Technical Service Bulletin

00 Bolts for the charging station are missing

00 21 45 2063335/1 May 17, 2021.

Model(s)	Year	VIN Range	Vehicle-Specific Equipment
Audi e-tron quattro, Audi e-tron Sportback	2021	All	e-tron

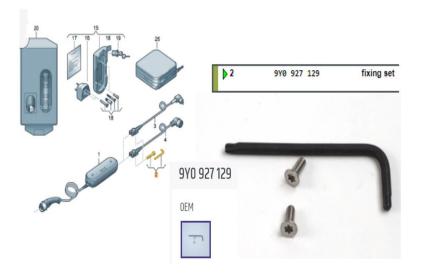
Bolts (part number 9Y0 927 129) for securing the connector in the charging unit have been discontinued (Figures 1 - 2).

As of production date 01/11/2021, the fixing bolts can be ordered via the parts system if the customer desired them but cannot be invoiced under warranty.
